CZ-23-1246656

STAFF ANALYSIS

Case No.:	CZ-23-1246656	Agenda #: 2023-1150
Location/Address:	1716 Pleasant Hill Trail, 7956, 7890, 8024, 7799, 7900 & 7860 Pleasant Hill Road Lithonia, GA 30058	Commission District: 05 Super District: 07
Parcel ID(s):	16-197-03-006, 16-197-03-012, 16-219-01-005, 16-219-01-006, 16-220-01-004, 16-220-01-007 & 16-220-01-009	
Request:	Major modification of zoning conditions pursuant to CZ-18-22130 to construct townhouses within the RNC (Residential Neighborhood Conservation) Zoning District.	
Property Owner(s):	Hybass Properties, LLC	
Applicant/Agent:	Hybass Properties, LLC c/o Battle Law, P.C.	
Acreage:	95.52 acres	
Existing Land Use:	Vacant	
Surrounding Properties:	North: R-100, MU-1, M-2 (Across Pleasant Hill Trail) East: R-85 South: R-85 (Across Pleasant Hill Road) West: R-75	
Comprehensive Plan:	Suburban (SUB)	Consistent <input checked="" type="checkbox"/> Inconsistent <input type="checkbox"/>

Application of Hybrass Properties for a major modification of zoning conditions pursuant to CZ-18-22130 to construct fee-simple townhouses within the RNC (Residential Neighborhood Conservation) zoning district, at Pleasant Hill Trail and Pleasant Hill Road.

CONCEPT PLAN
FOR
HYBRASS PROPERTIES, LLC
LOCATED IN:
LAND LOTS 197, 219, 220, 16TH DISTRICT
DEKALB COUNTY, GEORGIA

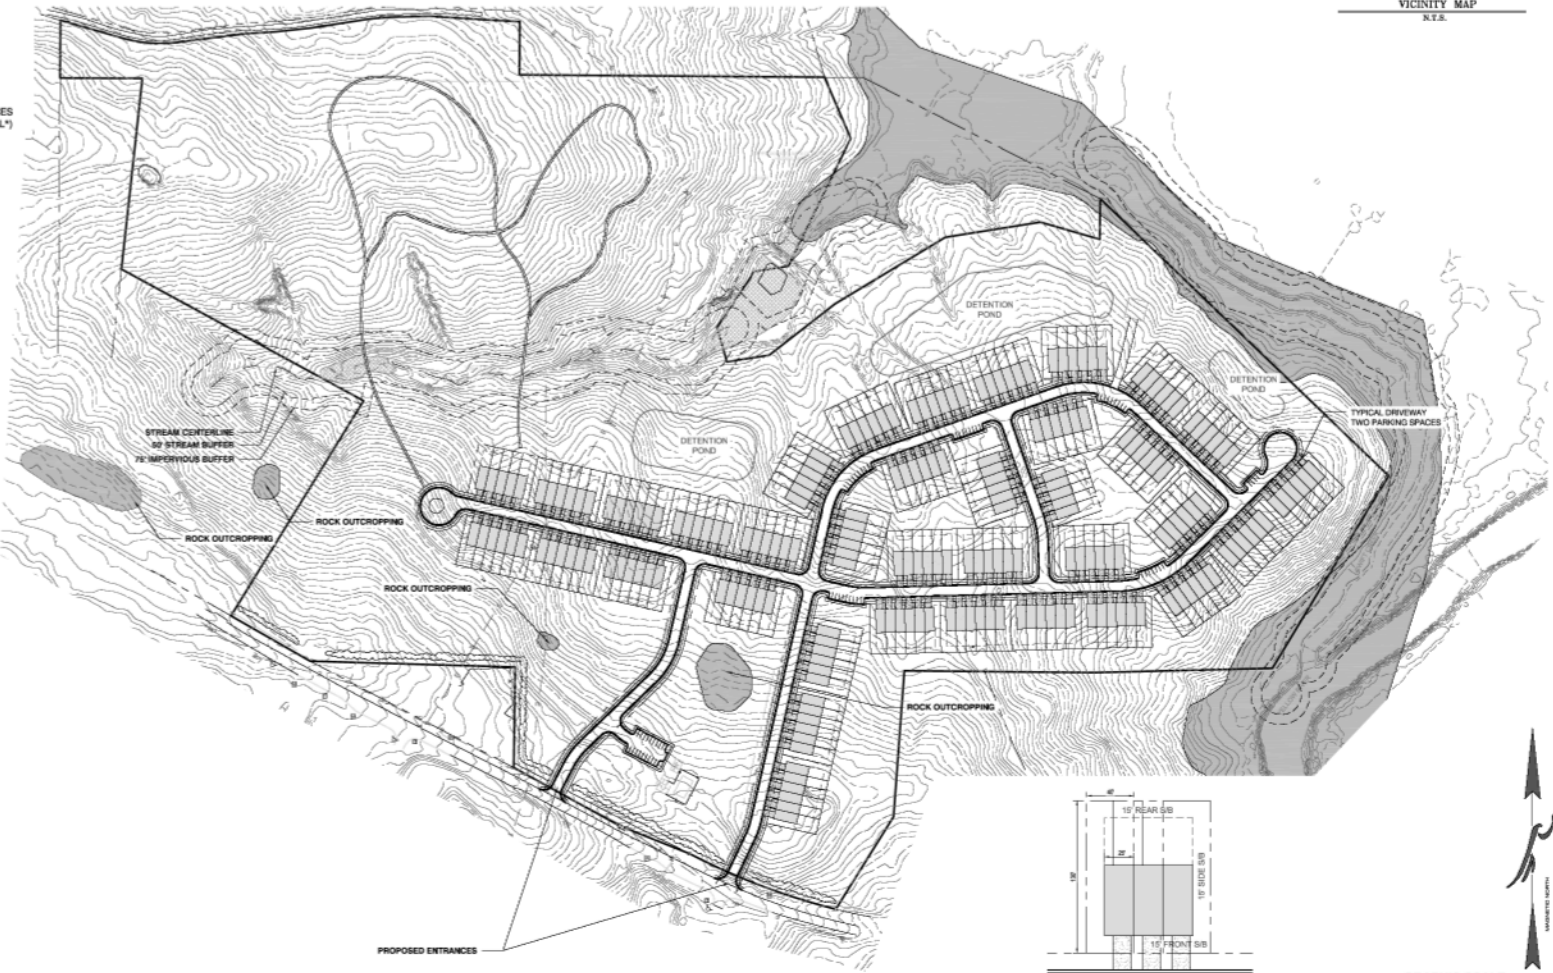
There are potential site plan deficiencies, however, that may affect the configuration and/or potential lot yield with the development:

- The applicant proposes a total of two (2) vehicle access points, down from four (4) that was originally proposed with the original submittal. Per Section 14-200 of the *Land Development Code*, a minimum of three (3) access points is required for residential developments with 151-300 total units. This requirement cannot be waived by a condition of rezoning and can only be addressed by a variance from the Planning Commission.

- The new site plan does not appear to prove compliance with the minimum greenspace requirement as defined per Section 2.10.5. of the *Zoning Ordinance*. A minimum of 30 percent of the total site area shall be dedicated to greenspace, which may not consist of the following features (per Section 2.10.5.(B)):

The site plan shows a development site that appears to have extreme slopes throughout, as well as having state waters/stream buffers. Meeting this greenspace requirement could pose a challenge for development and could affect lot yield.
